PHASE 1 SCHEMATIC DESIGN

NSW DEPARTMENT OF
EDUCATION

NORTH SYDNEY PUBLIC
SCHOOL

SEC. 4.55 MODIFICATION ITEMS

PLAN
PROPOSED SITE PLAN
SCALE: 1:500

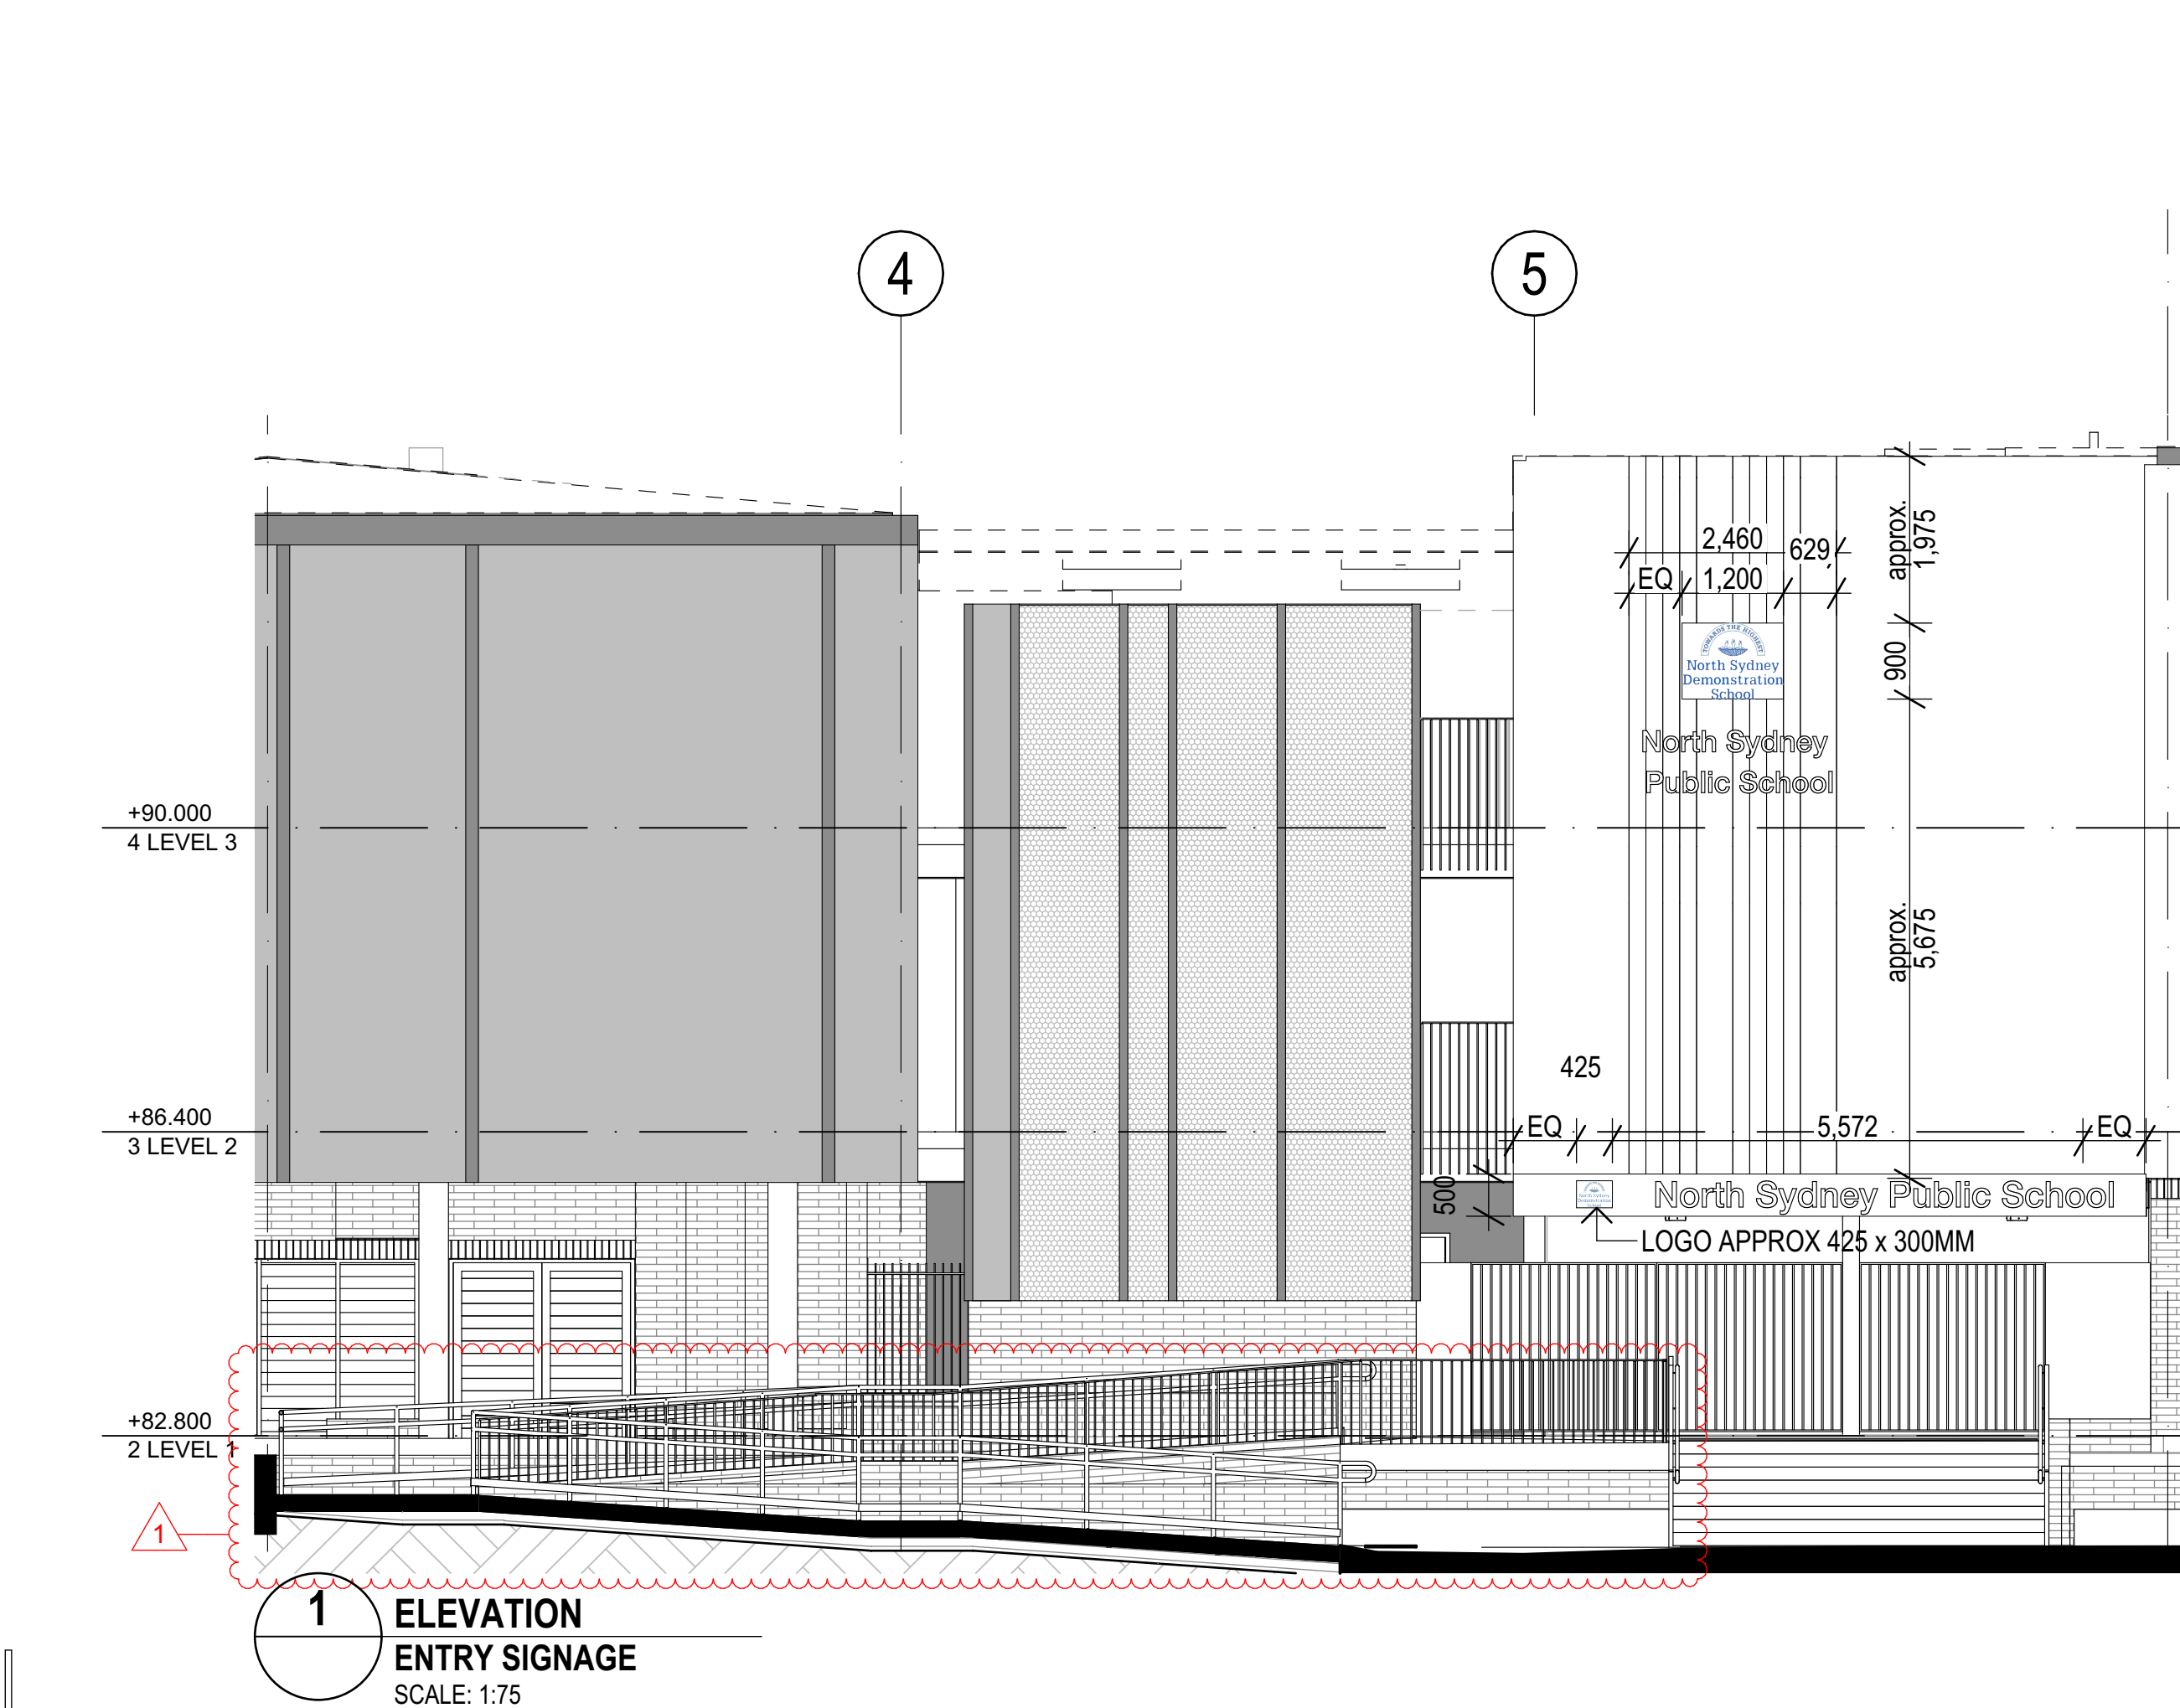
- ENTRY RAMP RECONFIGURATION TO BE 1:15, ADDITIONAL SLAB TO ACCESS PLANT ROOM
- HERITAGE FENCE TEMPORARY REMOVAL
- ADDITIONAL CLEANER'S CUPBOARD
- LIBRARY ENTRY DOOR MOVED DUE TO CLEANER STORE BEING ADDED, NOW ALIGNS WITH LIFT
- WALL ALIGNMENT OF WC'S LEVEL 3
- WINDOW CHANGES TO BUILDING I SOUTH & EAST ELEVATIONS ON L1 / L2 / L3. WINDOWS INCREASED IN SIZE FOR COMPLIANCE WITH BCA PART F4 - LIGHT AND VENTILATION. FIXED GLAZED PANEL INTRODUCED TO LOWER SECTION OF L2 / L3 WINDOWS TO MEET MIN 1200MM SILL HEIGHT REQUIREMENT IN EFSG. LARGER OPENABLE AWNINGS INTRODUCED FOR NATURAL VENTILATION COMPLIANCE.
- LOUVERED DOORS CHANGE FROM SINGLE TO DOUBLE DOOR TO SUIT PLANT ROOM REQUIREMENTS.
